APP REF: P/OUT/2023/02644

ADDRESS: Land West of Church Hill and Land off Butts Close and Schoolhouse Lane, Marnhull

URBAN DESIGN OFFICER COMMENTS

Excerpt of Block Plan

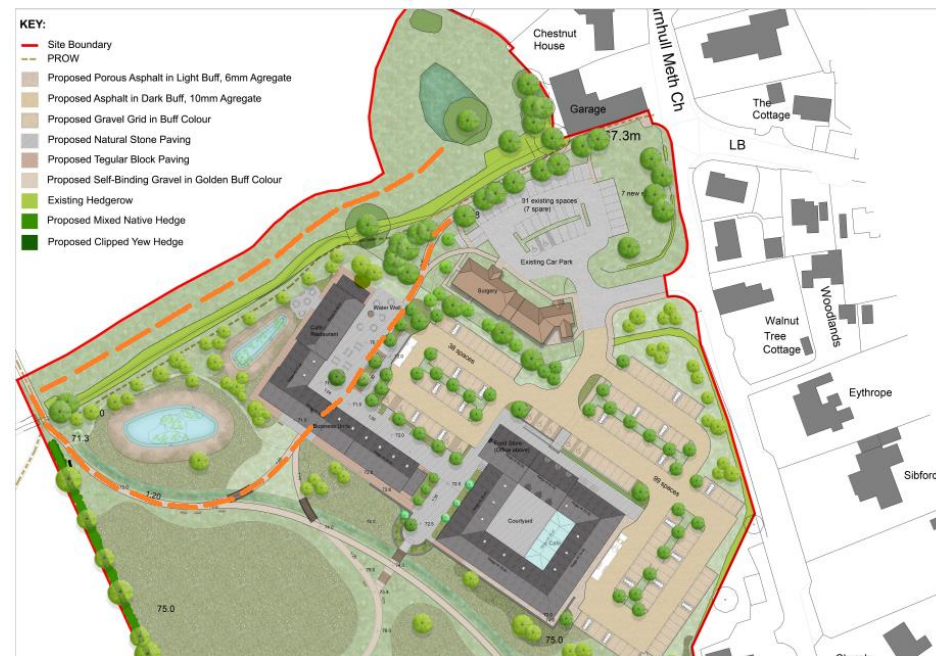
and N47/33 to the north west of the site. Proposed pathways through the site are shown to provide links between the retail and commercial development, the school drop off area and to the school beyond the site, with paths meandering through the POS while providing direct links. The proposals appear to involve a re-routing of PROW N47/30 in order to bring the ROW through the commercial / retail units, but clarification is required on this as the site plan appears to still show N47/30 as it is currently (as shown below).

This is repeated for PROW N47/31 which does not appear to tie in with the footpaths that are shown to meander through the POS within these proposals (as shown over the page). The application needs to address the rights of way on site to ensure that the wider links beyond the site are facilitated. The proposed on-site footpath network should either incorporate existing PROW or make provision for amendments to these routes to tie in with the links to the proposed development. Paragraph 100 of the NPPF states; *“Planning policies and decisions should protect and enhance public rights of way and access, including taking opportunities to provide better facilities for users, for example by adding links to existing rights of way networks including National Trails”*. Where active travel is promoted, the National Design Guide (NDG) states that *“Public rights of way are protected, enhanced and well-linked into the wider network of pedestrian and cycle routes”*. Policy 24 of the North Dorset Local Plan (NDLP) stipulates that; *“Layouts should be designed to promote accessibility and local permeability making connections with neighbouring areas and reinforcing existing connections”*.

Annotated Block Plan

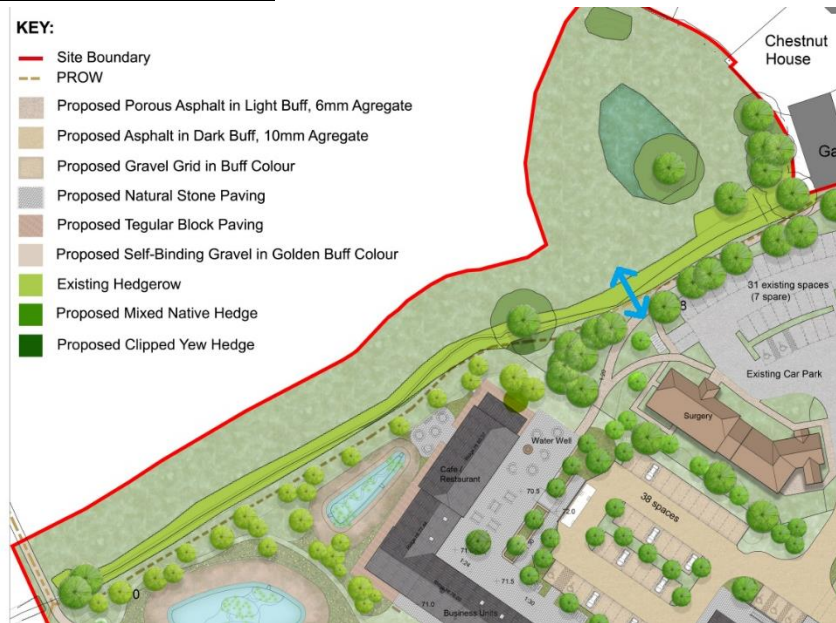
The relationship between the open space and the proposed development is generally shown to be a positive one. However, in their current form the proposals would see the area of open space at the north of the site severed from the rest of the development. The hedgerow would act as a barrier to pedestrian movement into this space and it is unlikely to be utilised if pedestrians have to take the route highlighted in orange on the annotated block plan below.

A link to this space, as shown by the blue arrow on the annotated block plan below, would serve to open up this space for further public amenity space.

Excerpts from the indicative site plan

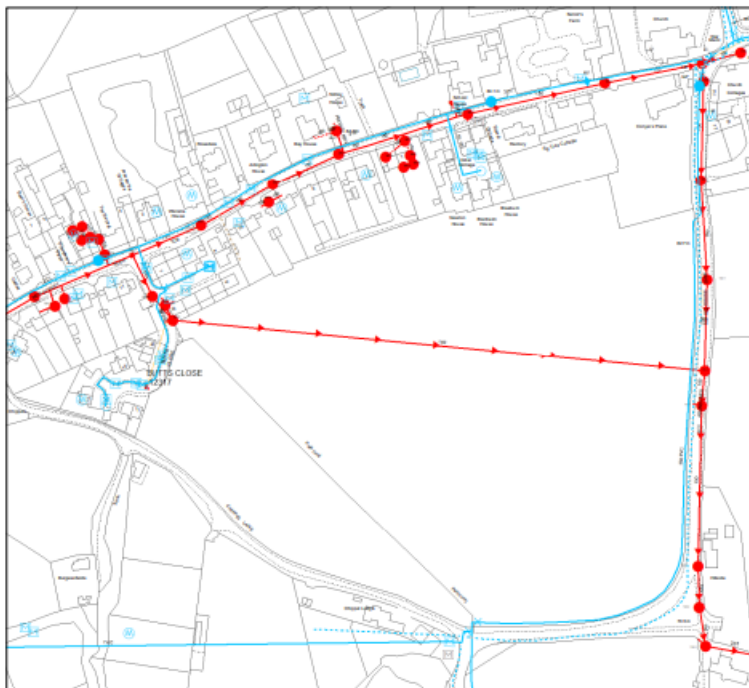
There are numerous examples of front to back orientation of dwellings on the indicative layout where incomplete perimeter blocks expose plot boundaries to public spaces and blur what is private space from public space. Manual for Streets (MFS) states; “*In general, it is recommended that streets are designed with the backs and fronts of houses and other buildings being treated differently. The basic tenet is ‘public fronts and private backs’*”.
